Attachment 1:	Boffa Miskell 15 March 2019: Canterbury Coal Mine RFI Response: Ecological Impact Assessment Report
Attachment 2:	Boffa Miskell 23 November 2017: Canterbury Coal Mine Tara Stream Sediment Retention Pond Ecological Assessment
Attachment 3:	Boffa Miskell 12 January 2017: Canterbury Coal Mine Ecological Significance Assessment of Tara Stream Wetland, the Northern Elf and Bush Gully Stream
Attachment 4:	JH Rekker Consulting Limited 16 December 2019: Response on Hydrological Matters
Attachment 5:	CCR Discharge to Land Resource Consent Application
Attachment 6:	Tips Dams and Voids Principal Hazard Management Plan (PHMP)
Attachment 7:	Ground or Strata Instability PHMP
Attachment 8:	CCO2tele Water Quality Monitoring Results

#	Further Information Request	Response
1	Please provide a map identifying all individual seepages/wetlands located inside the MOA (Mine Operating Areas) and within the zone of influence. This map should include the seep/wetland boundary and identify the location of seeps/wetlands that may have already been removed from any location within the MOA.	<p>An assessment of the effects of mine operations on the ecological values has been prepared by Boffa Miskel

Figure 8 Landform and surface water at baseline

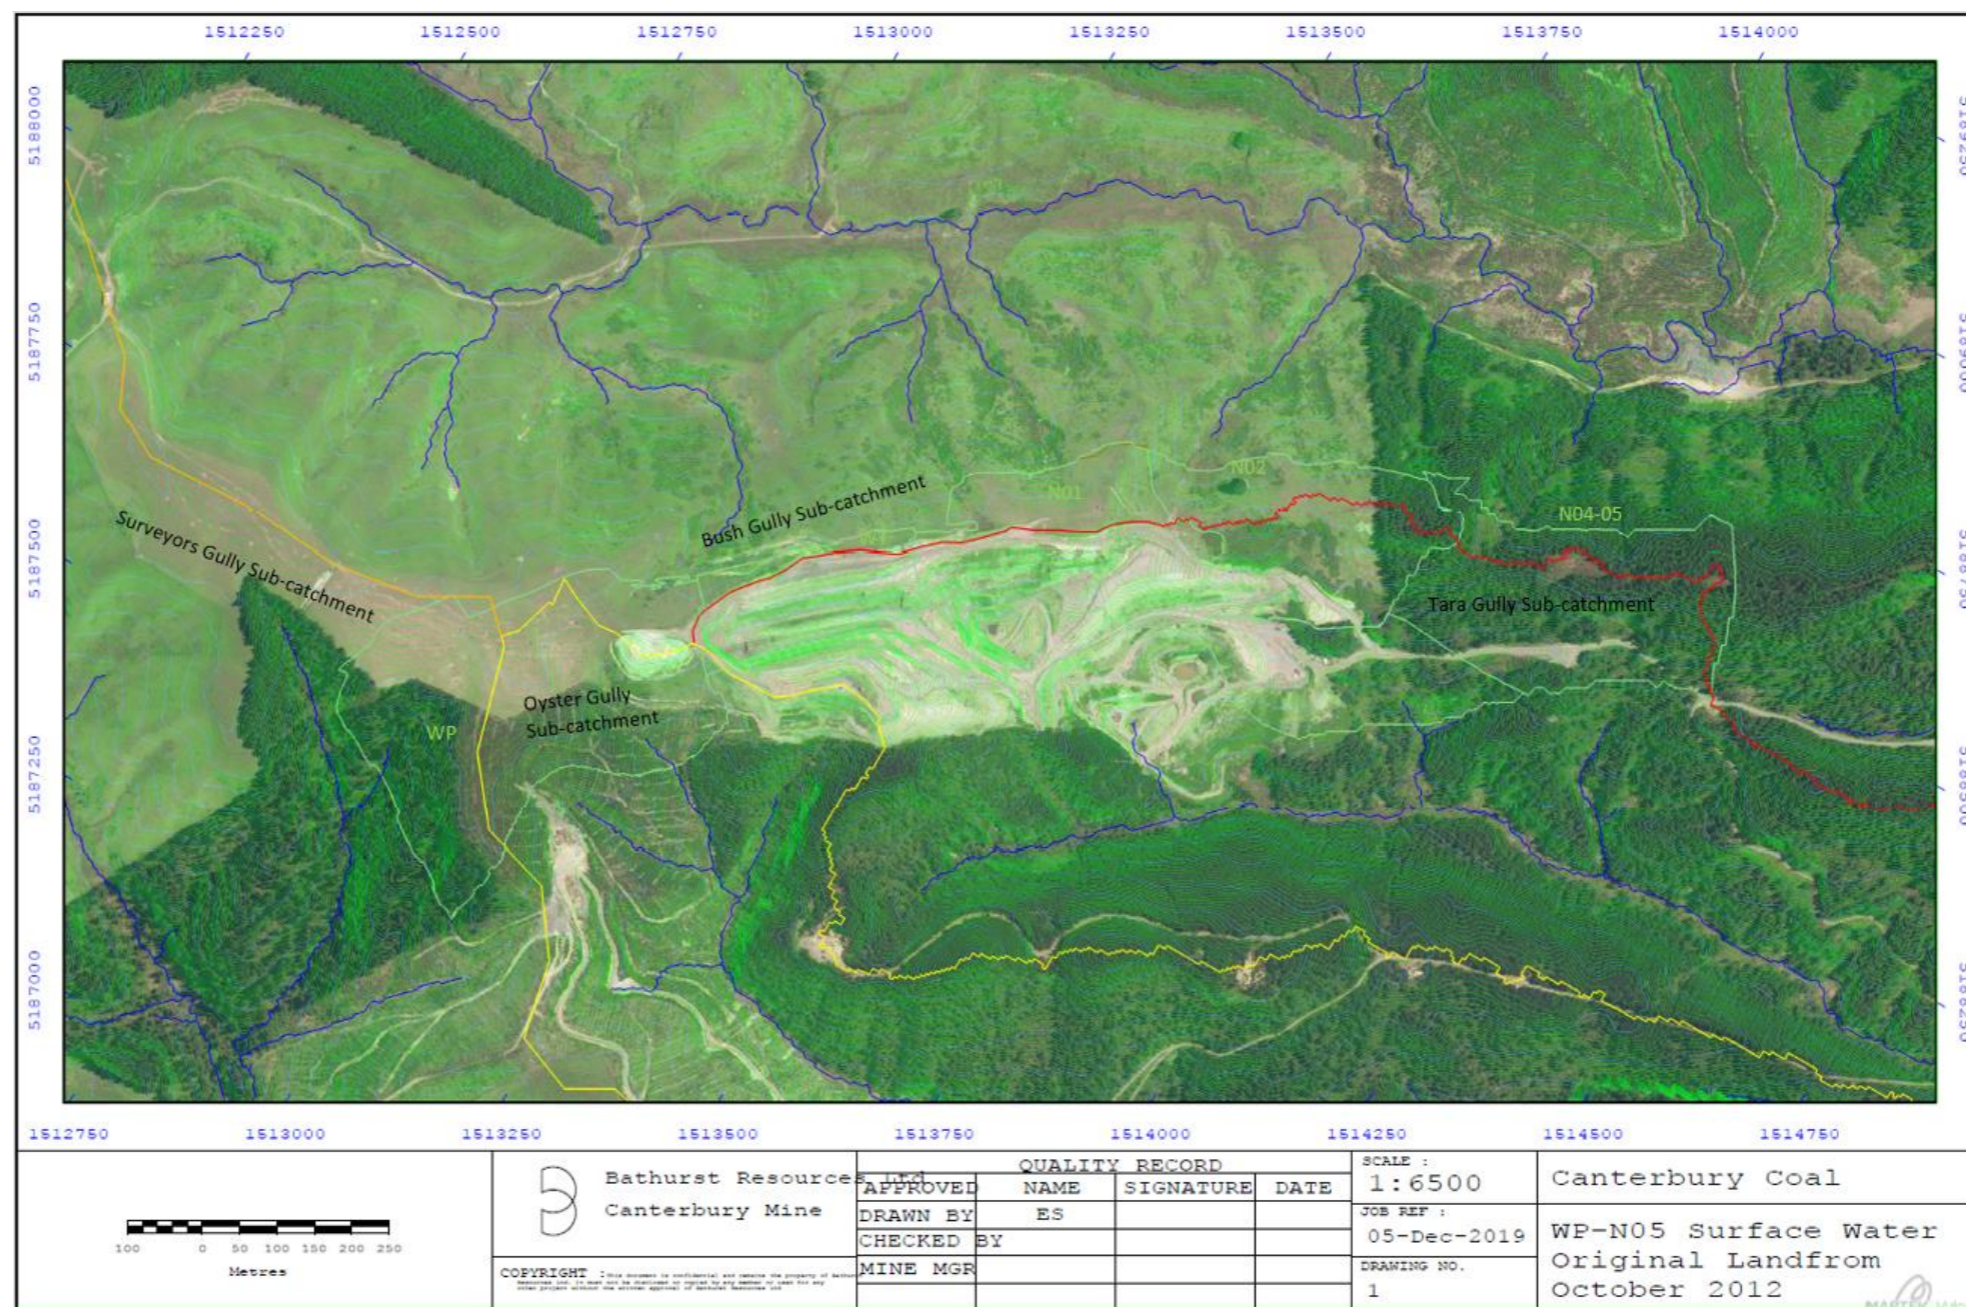
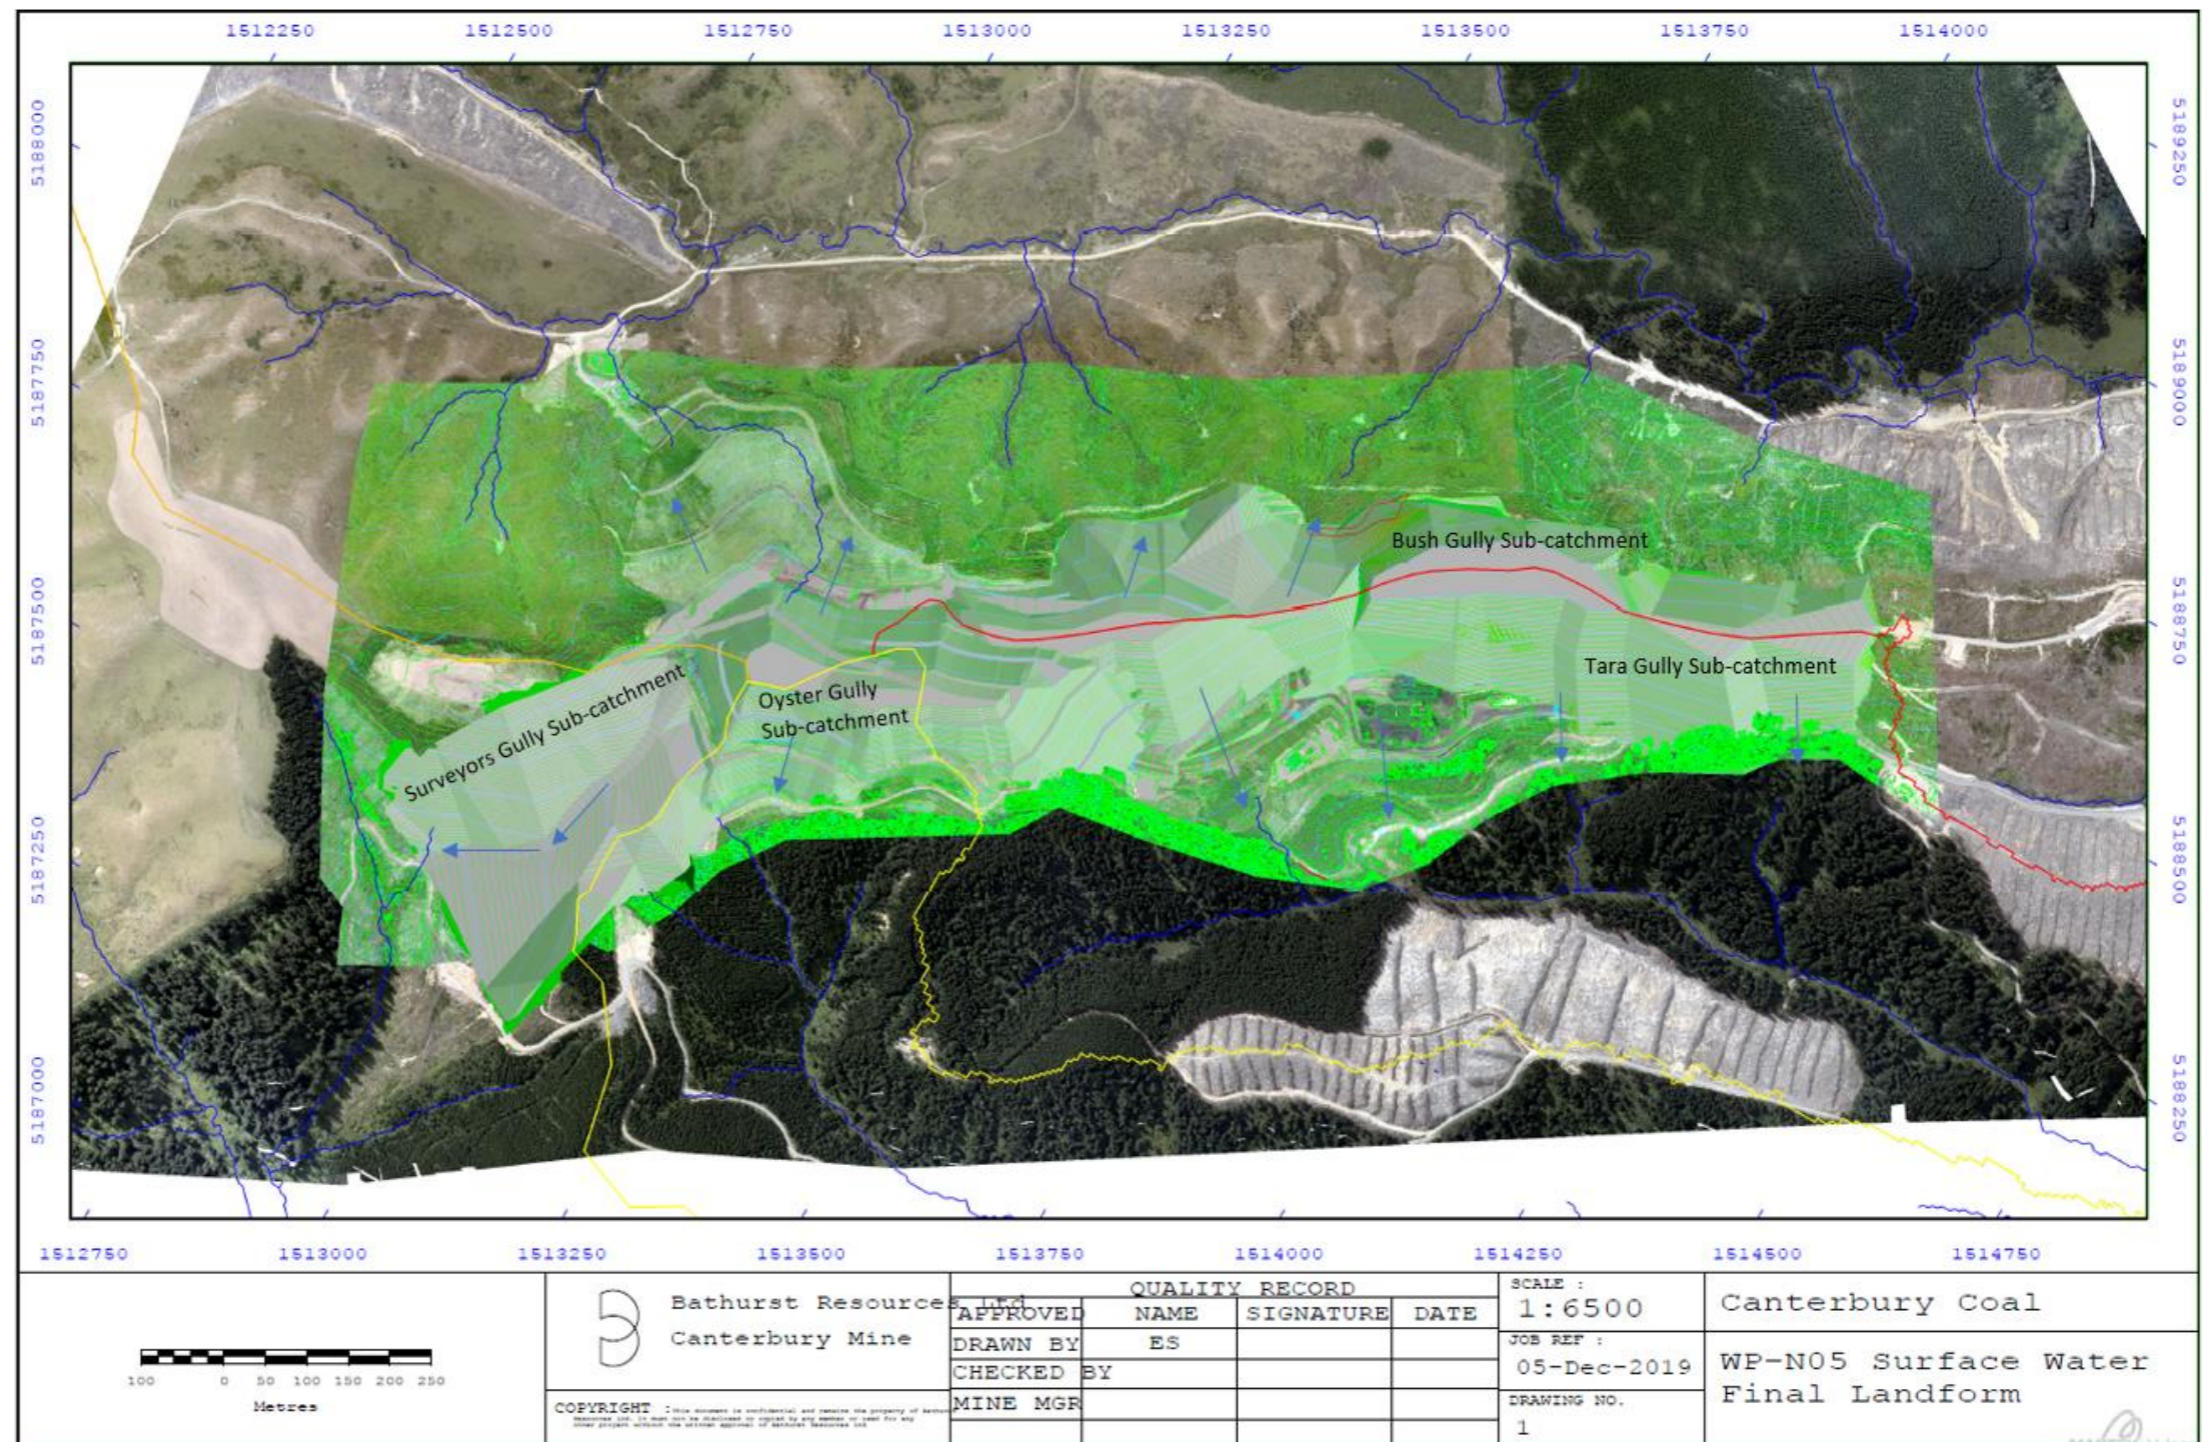
10	Please provide an assessment of potential effects of altering drainage patterns on any seepages or wetlands on the north-west slopes, the south-east gullies and Tara Stream and any subsequent changes in flows to receiving waterbodies. This assessment should identify any retrospective effects and future effects and also effects both inside and outside of the MOA.	<p>BCL has agreed with the landowners of the site that once mining is complete the land will be rehabilitated as far as practicable to its former condition, or to an alternate condition that is agreed between the relevant parties involved. Objectives guide the rehabilitation of the site in that it shall be physically, geotechnically and geochemically safe. This is set out in the EMP. The land is being progressively recontoured and rehabilitated as mining progresses through the site. During operations, runoff from the ELF's will be directed toward the storage and treatment ponds, mimicking the natural direction of runoff from the areas. The storage and treatment ponds will remain in place following the completion of the mining at the site, and upon mine closure these will be remediated as a wetland habitat. The final contour of the landform will be such that there is no ponding or pooling of water, or accelerated runoff so as to prevent any significant erosion or sediment runoff from the final landform. Over time it is anticipated that the natural drainage channels and overflow pathways within the site would return to their natural state. This is further demonstrated in Figures 8 and 9 below and also within the memo prepared by Jens Rekker (refer Attachment 4).</p>

12	<p>Please provide map identifying all surface water bodies and other surface water features such as artificial drains and ponds, wetlands, springs and seeps in accordance with the definitions in the CLWRP. The map should include where possible the water quality management unit where mapped on the CLWRP Planning Maps. Please also identify any water features that may have been removed and their previous location.</p>	<p>Maps depicting the location of artificial drains and ponds that form part of the surface water treatment system were shown in Figure 8 of the AEE attached to the application to take, divert and discharge water from two additional land parcels (refer CRC201368). Figure 8 below shows the surface water bodies within vicinity of the mine. Figure 1 above provides an overview of the existing wetland and seepage areas within the MOA and surrounds. The relevant water quality map (Map A-057) indicates that the surface water bodies surrounding the site are classified as “Hill-Fed Lower”.</p> <p>Figure 8 below shows the sub-catchments and flow paths as at October 2012. The red, yellow and orange lines present the sub-catchment boundaries.</p> <p>Figure 9 below shows the sub-catchments and flow paths after completion of the final landform. The red, yellow and orange lines present the sub-catchment boundaries.</p>

13	Based on the map, please describe if works have or will be undertaken in riparian margins and if consent is necessary under Rule 5.169.	<p>Due to the elevated location of the site, there are no lakes or rivers affected by any works (with the exception of those consented as part of the Tara Pond #2 consents CRC183000), but there may be some seepage wetlands within 10m of the working areas of the site as discussed in response to questions 1 and 2 above. A separate application is however not considered necessary as the area is similarly within scope of the current applications that have been prepared and in particular the earthworks consent that is being sought, however it is acknowledged that an assessment in accordance with Rule 5.169 is necessary. This is provided below.</p> <p>As set out in response to question 2a above, while there is not anticipated to be any direct impacts to the wetlands, aside from those already identified and consented, there is potential for the excavation of overburden and coal within the pit shells to indirectly affect these water bodies. It is reiterated that sedimentation impacts are however very unlikely because the face of the pit is excavated to create a steep scarp facing into the mine pit. Sediment discharges and contaminants from the active mine areas are also directed through the water treatment ponds within the Tara Stream catchment and suspended sediment retention ponds in the Bush Gully Stream catchment. Run off from the mine site is directed through these sediment ponds and includes flocculent dosing, active and passive Acid Mine Drainage (AMD) treatment, with the capacity to retain water during rain events. This treatment is effective in maintaining the quality of any water bodies immediately surrounding the MOA as the majority of any direct runoff is prevented.</p> <p>Specific erosion and sediment controls that are currently being adopted throughout the mine site will also ensure the protection of surrounding wetland and seepage features. These controls are explained in the EMP attached as Appendix 11 to the application to discharge water and take, use and divert water and includes the installation and use of silt fences, silt socks, sedimentation ponds (refer above), and progressive rehabilitation requirements.</p> <p>Overall it is considered that these measures will ensure that wetlands surrounding the MOA are largely unaffected, and post closure there will be no long term effects anticipated as the land will be rehabilitated to encourage natural drainage patterns and functioning. Final landform catchment boundaries largely follow the original catchment boundary as shown in Figures 8 and 9.</p>

Figure 10: Rainfall by month as recorded at the ECan Whitecliffs weather station

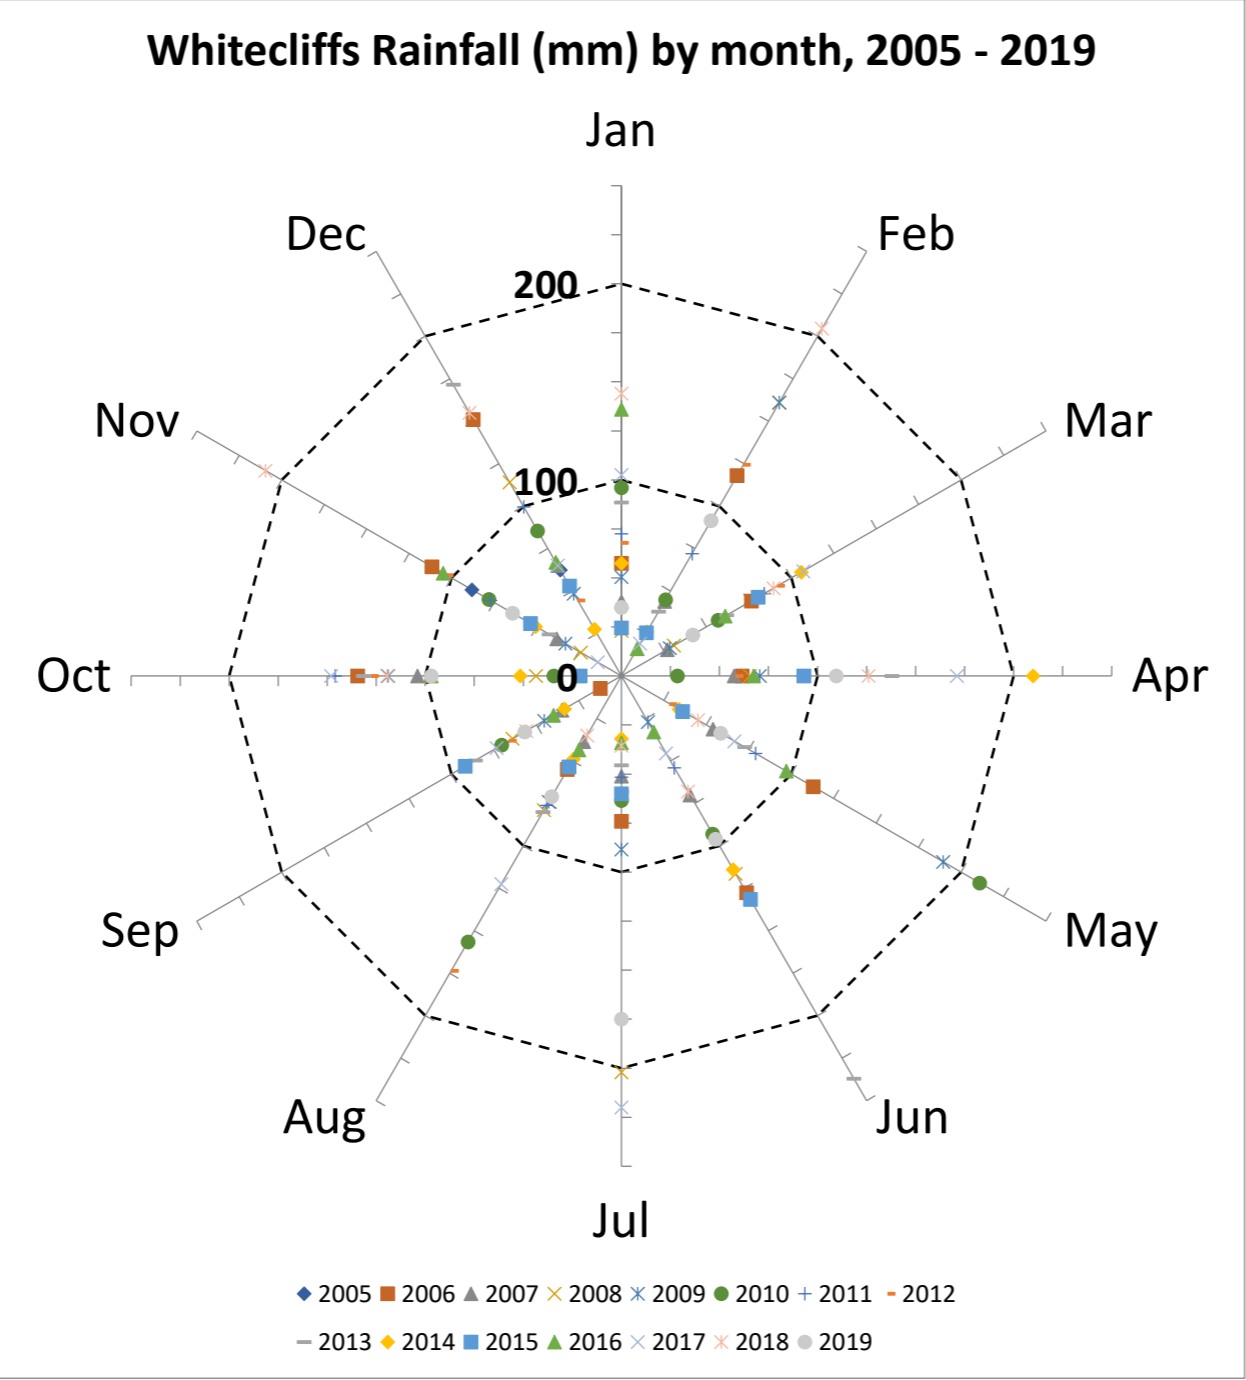
3 Please provide more analysis of climate conditions during and preceding sampling to assist in interpretation of discharge water quality patterns (particularly 2018-2019 if these are being used to demonstrate a new state?).

As per conditions of CRC170541, weather and rainfall is recorded for the day of and the day prior to the manual compliance samples being taken. Such results are provided to ECan as part of BCL's reporting obligations under its existing consents, the latest of which was provided to ECan on 26th November 2019.

Below (Figure 10) is a chart showing rainfall by month as recorded at the ECan Whitecliffs weather station:

Figure 11: CC24 Compliance Record

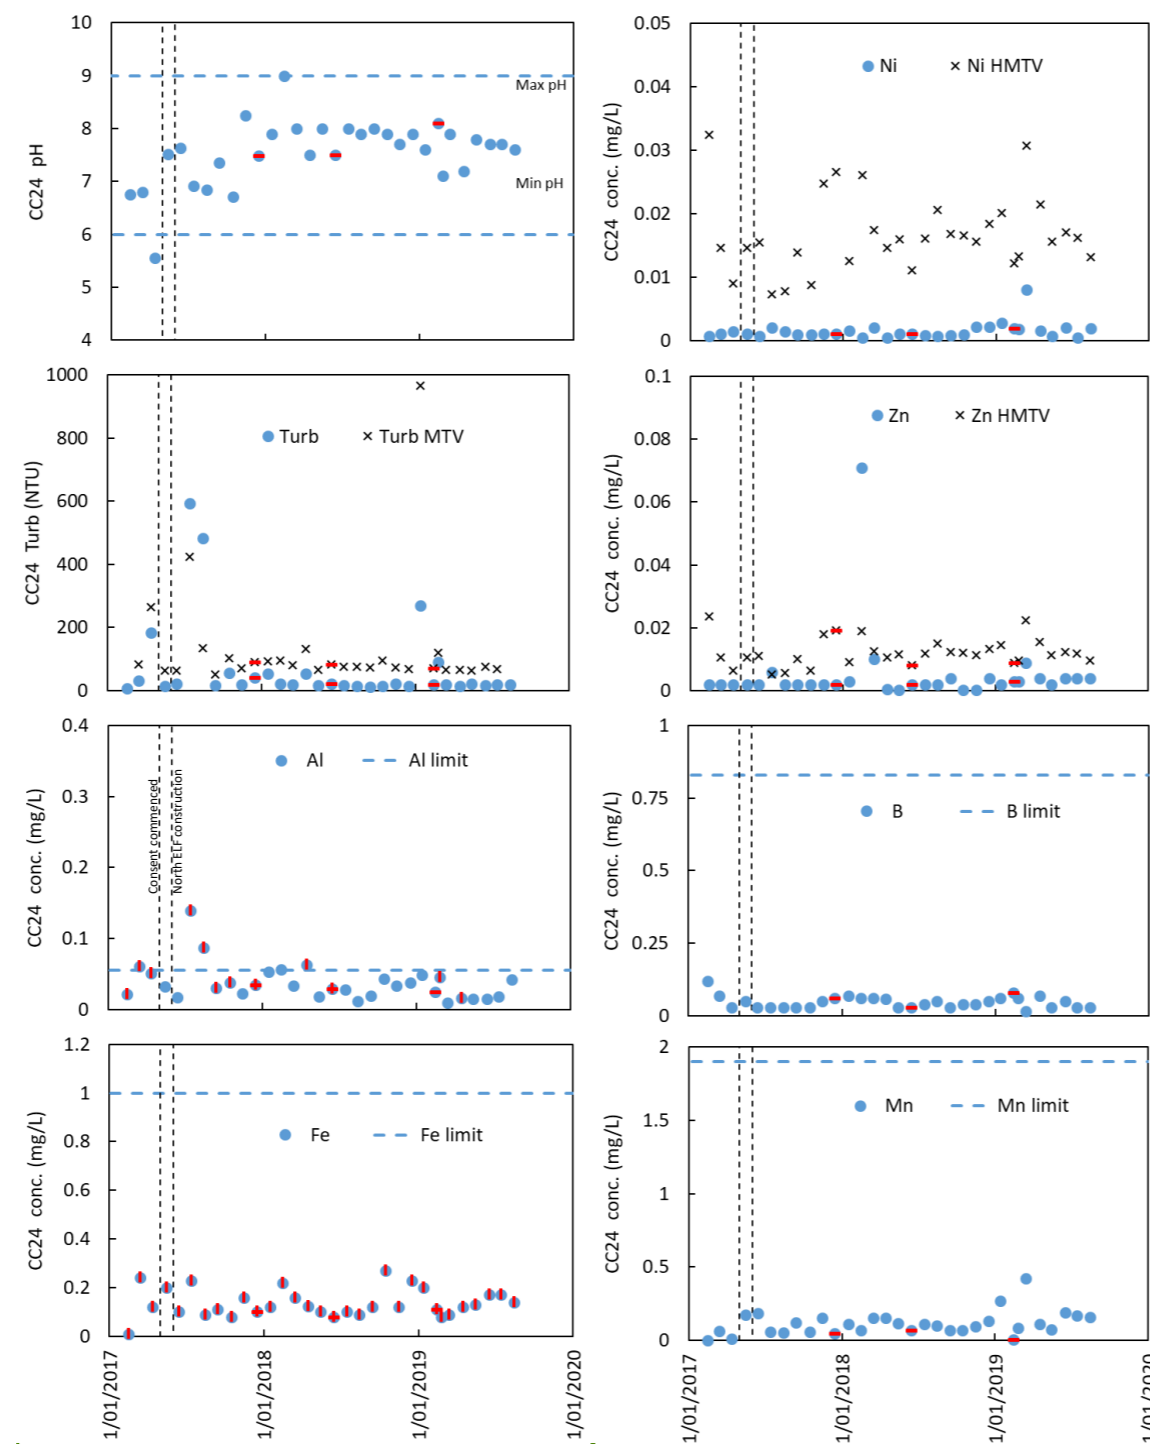
What information is there to support the assessment that these classic AMD type discharge/contaminant sources can be controlled into the future at the mine-site?

Figure 11 shows CC24 monitoring data compared against compliance limits.

Although there were some exceedances for turbidity at the CC24 compliance site shortly after North ELF construction commenced monitoring data show consistent CC24 compliance since mid/late 2017 (**Figure 11**).
